Rev	Description	Date
P1	Planning Issue	02.05.19
P2	Planning Landscape Revision	10.05.19
P3	Planning Sign-Off	17.05.19
P4	Planning Landscape Revision 2	31.05.19
P5	Planning Drawing Updates Following Design Development	06.09.19
P6	Planning Non-Material Amendments	05.02.20

Project
Salford Central
Trinity Way, Salford

Drawing
Proposed Level 11 GA Plan

Drawing No.
SALC-HBA-C1-11-DR-A-PL20_0111

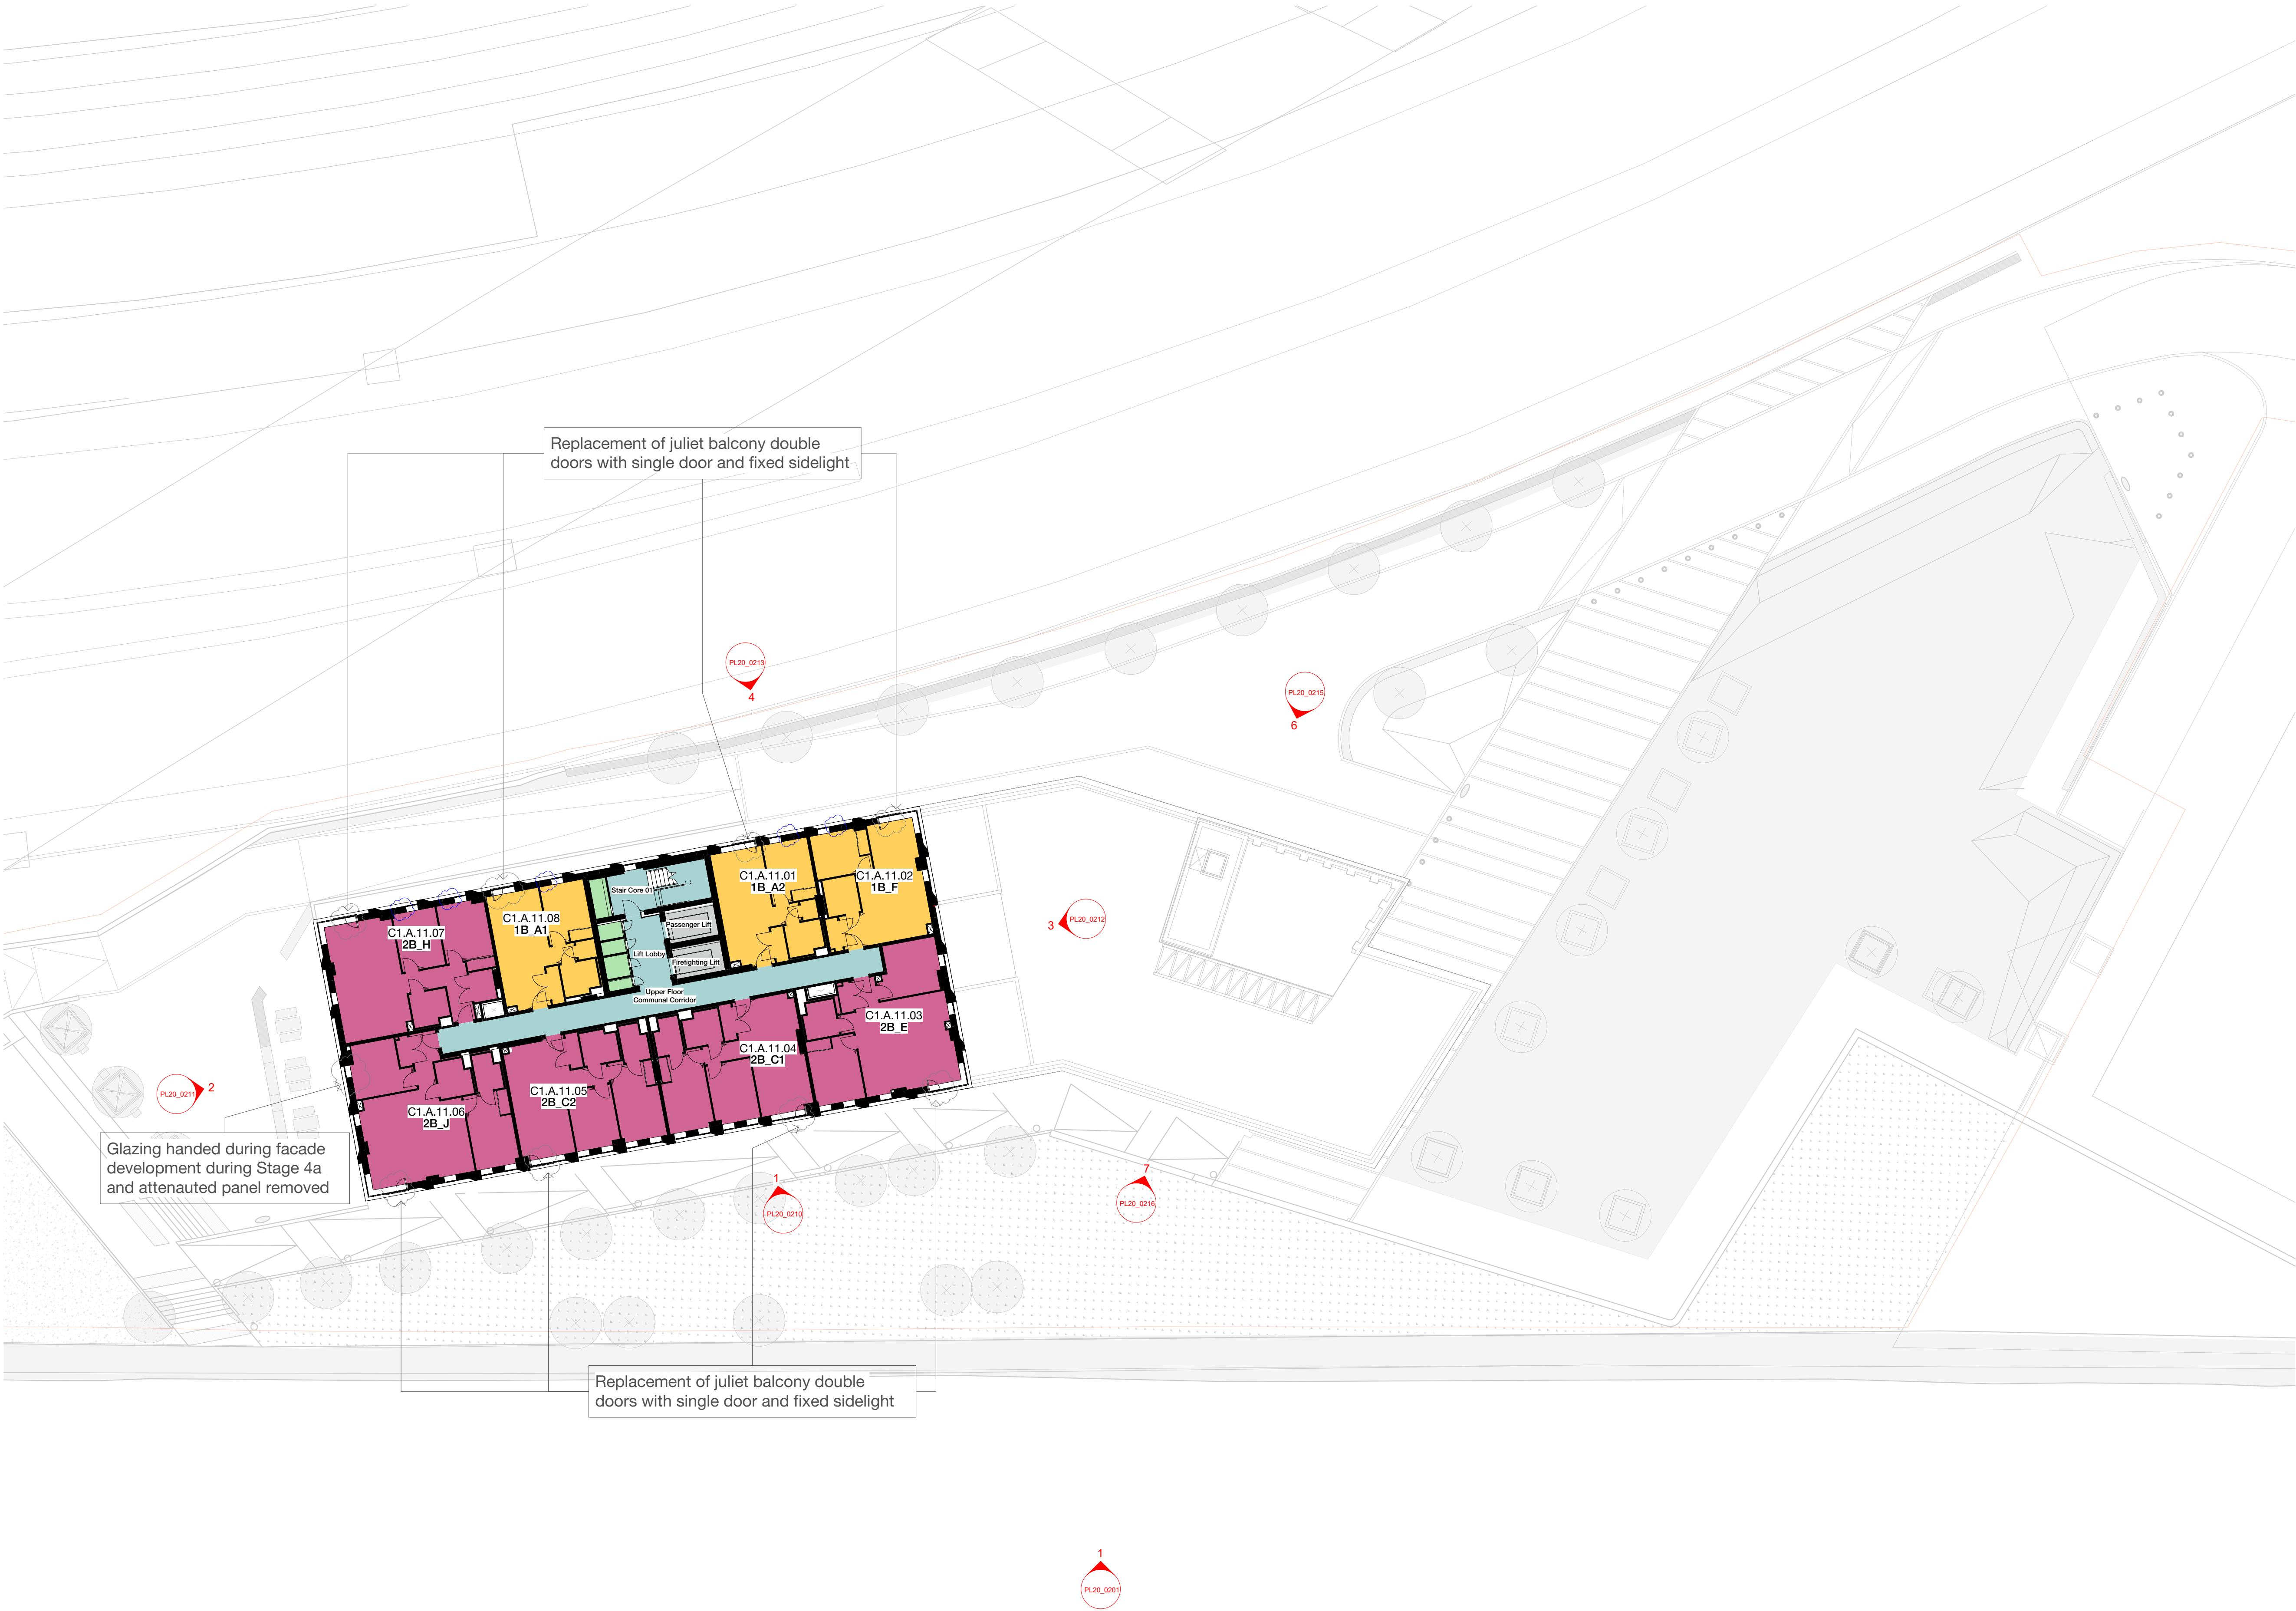
Update to facade chamfers - rationalisation and reduction in types

Update to projecting and corner balcony balustrades - replacement of laminated glass balustrades with PPC aluminium balustrades with perforated design.

Update to juliet and recessed balcony balustrades - replacement of laminated glass balustrades with flat rail steel design.

Update to ventilation strategy to north and west facades - removal of attenuated panels.
